**Re: Case SP-22-02, Proposed Electric Vehicle Charging Facility for KO-GO LLC;  
Technical Review Group Response.**

The following is a summary of action taken to address the comments from the February 3, 2022 TRG meeting and follow up comments posted on the City of Rochester View Point Cloud for the proposed major Non-Residential Site Plan Review Application for KO-GO LLC located on Farmington Road. To expedite the review process; I have listed the different departments comments and our responses.

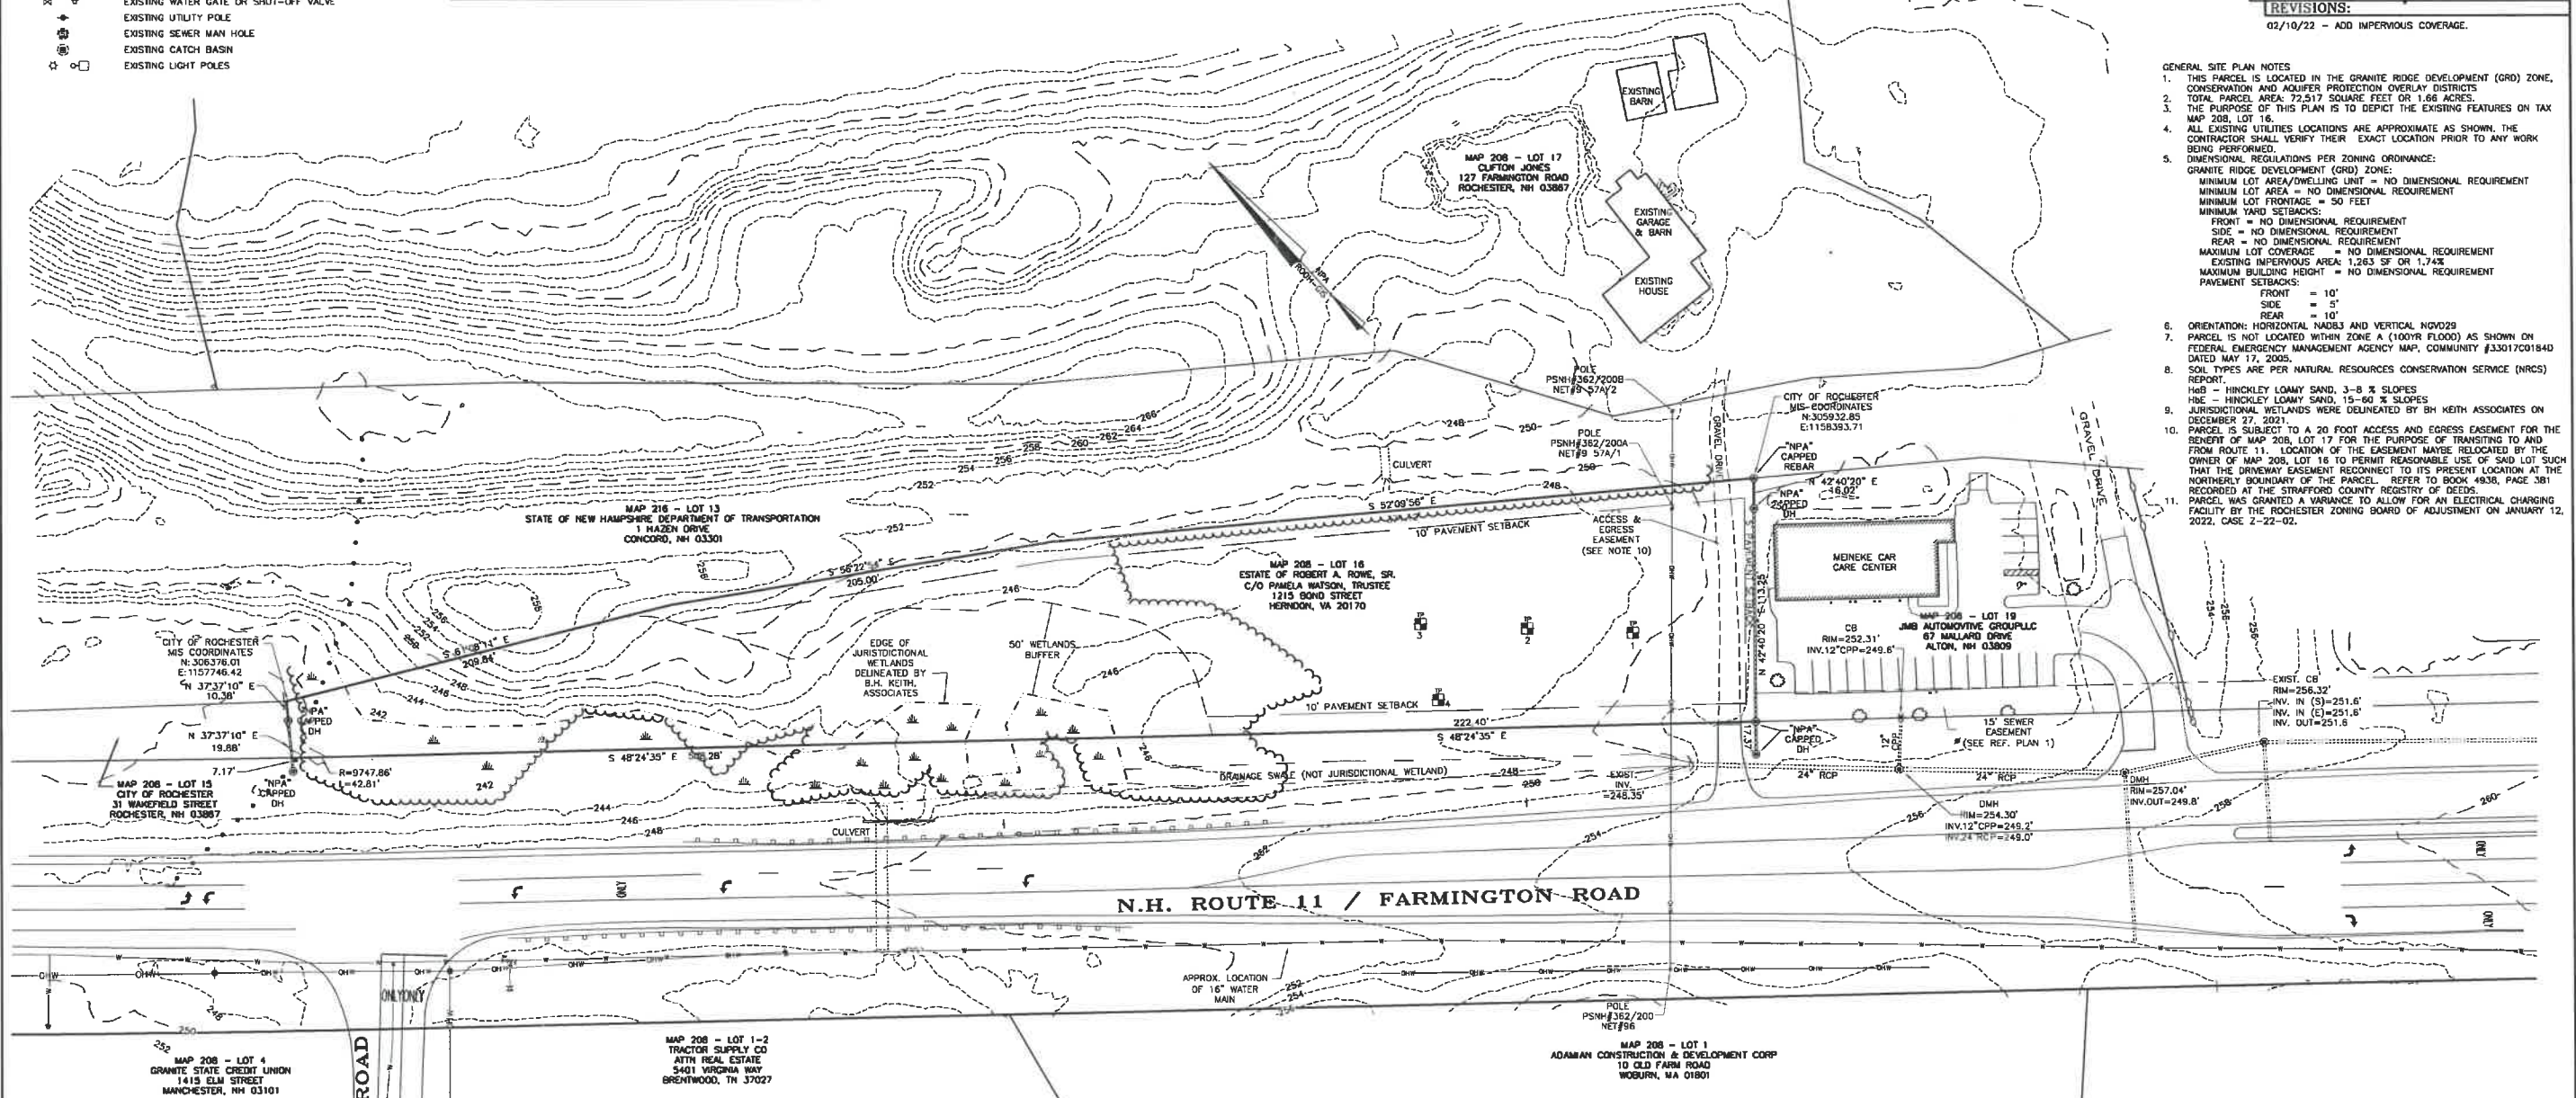
- a) Please show the square footage of Impervious area for the site:
  - *The square footage and percentage of the overall parcel were added to the Existing Features Plan (Sheet E-1) and Overall Site Plan (Sheet C-1) under General Site Plan Note #5.*

REVISIONS:  
02/10/22 - ADD IMPERVIOUS COVERAGE.

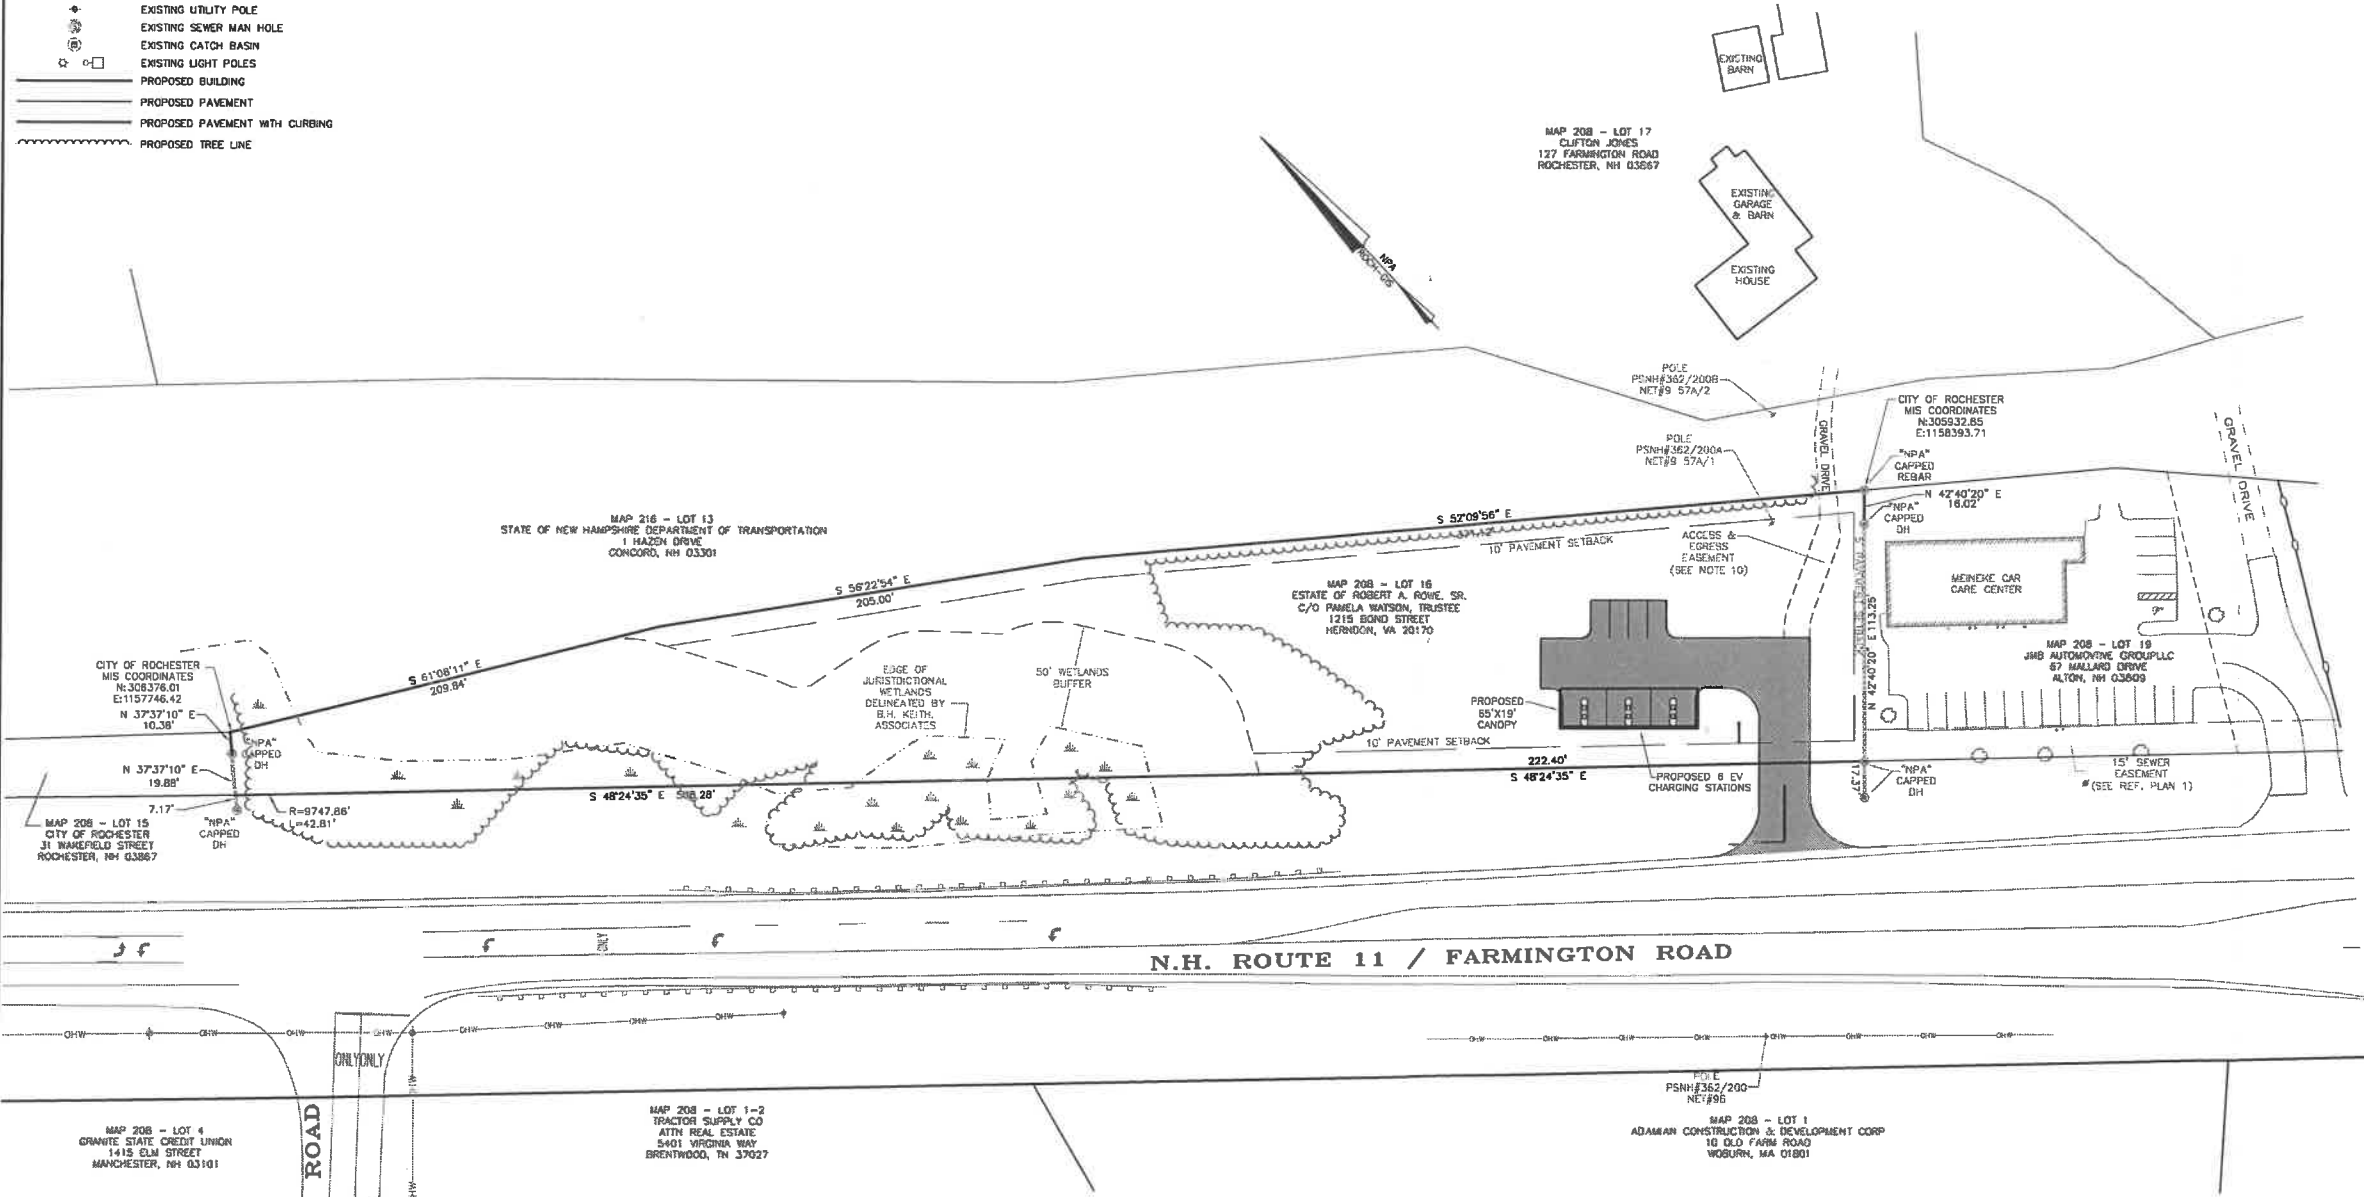
- f) Our site plan regulations require a pitched or more traditional roofline for the canopy. Below are the requirements, please contact staff with any questions: (Site Plan Regulations, Section 2, Architecture (H) Particular Building Types &. Components).

- *The plan set has been amended to depict a sloped roofline for the canopy. The roofline will be pitched toward Route 11 / Farmington Road.*
  - *Please find an example of the proposed canopy that is being proposed. Detailed plans will be prepared and submitted as part of the building permit phase.*

02/10/22 - REVERSE CANOPY SIZE AND CHARGER UNIT LOCATIONS, ADD IMPERVIOUS COVERAGE.
